**DOE/OR/01-2304
FINAL-CONCURRED**

**Environmental Baseline Survey Report
for the Title Transfer of
Land Parcel ED-4
at the East Tennessee Technology Park,
Oak Ridge, Tennessee**

**Subject: REQUEST FOR CONCURRENCE IN THE DEPARTMENT OF
ENERGY'S CLEAN PARCEL DETERMINATION TO SUPPORT
TRANSFER OF PARCEL ED-4 AT THE EAST TENNESSEE
TECHNOLOGY PARK, May 12, 2008**

Fig. 1.1. Location map of the Parcel ED-4 study area.

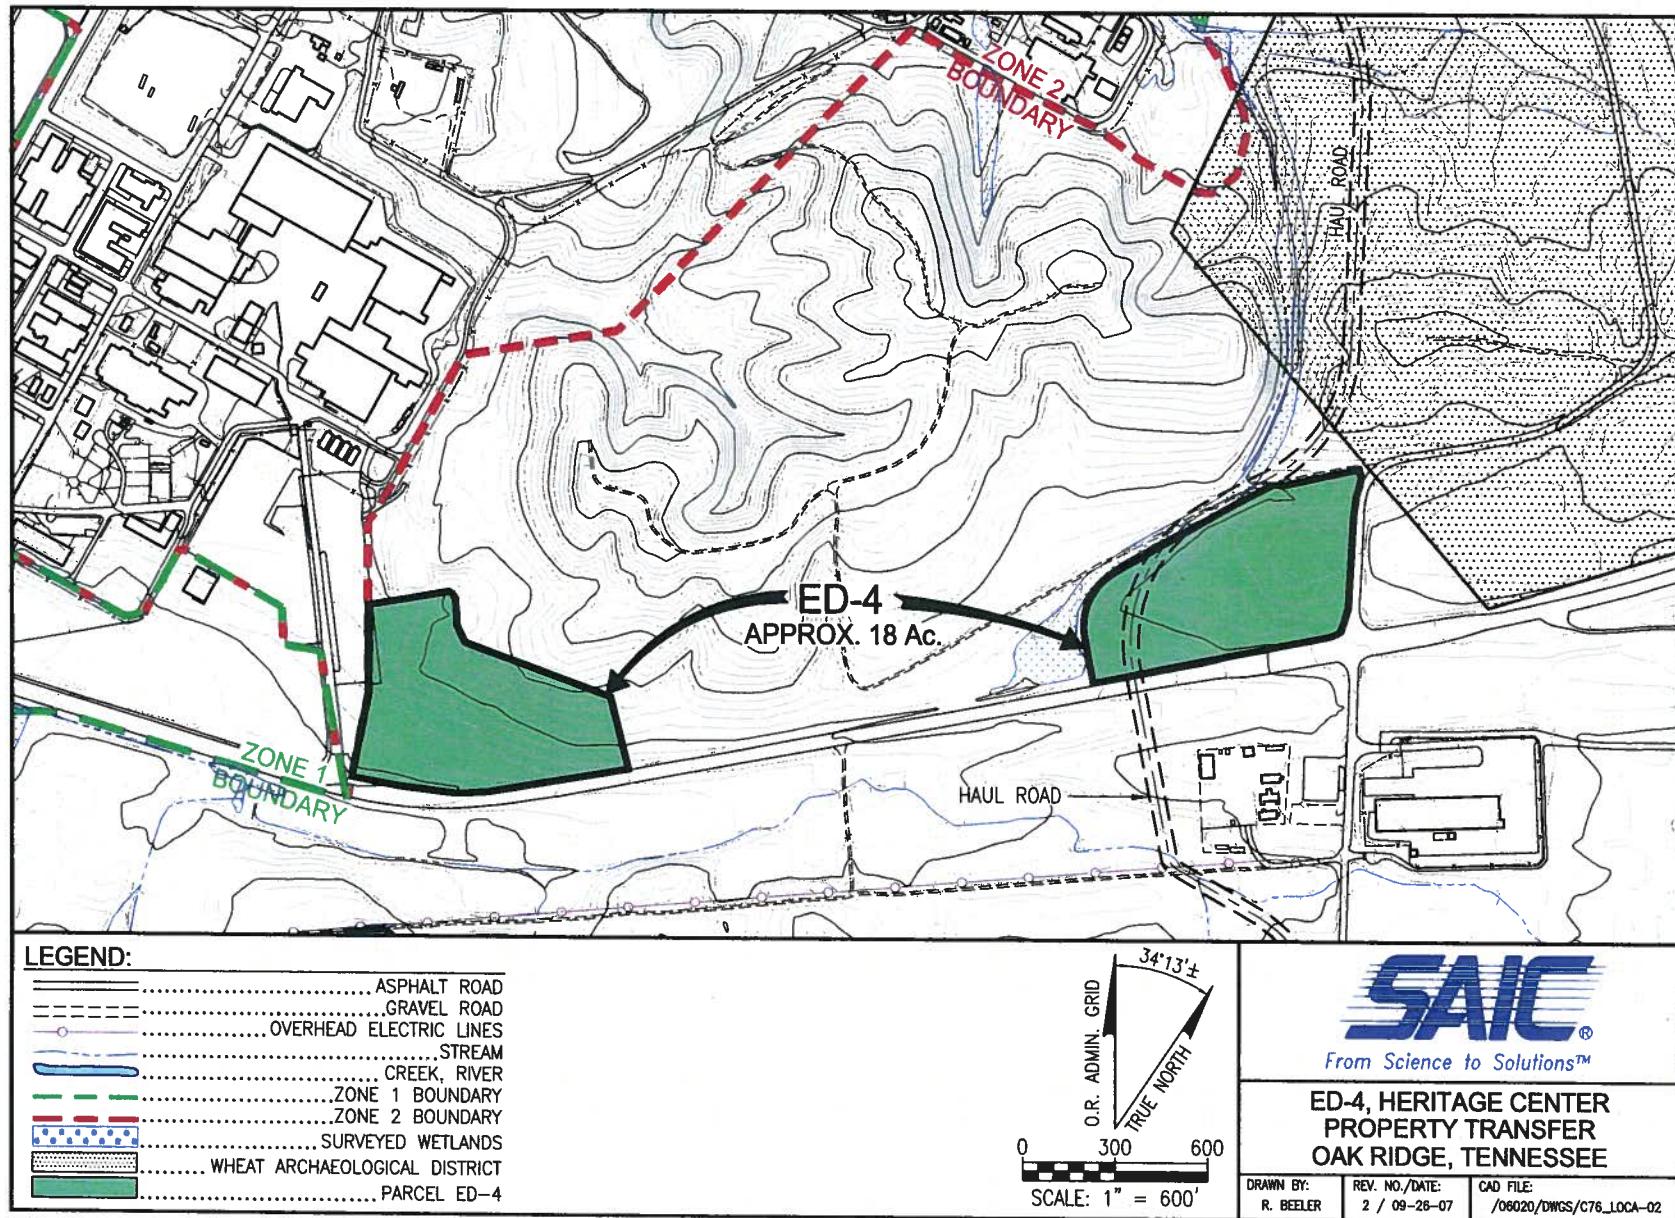
1. **Page 1-3.** The ED-4 boundary reflected in the figure is not accurate. Please modify this figure.

DOE RESPONSE: The label for the boundary in the figure has been revised to note that it is the "ED-4 area". (It should also be noted that adjustments have been made to the proposed transfer footprints from DOE's initial notification of the intent to transfer that was issued in April 2007. The primary change to ED-4 was the reduction in the size of the footprint of the eastern parcel to avoid the wetlands. The notification letter was intended to communicate DOE's overall plan, other minor changes may occur prior to transfer, especially to accommodate the metes and bounds survey.)
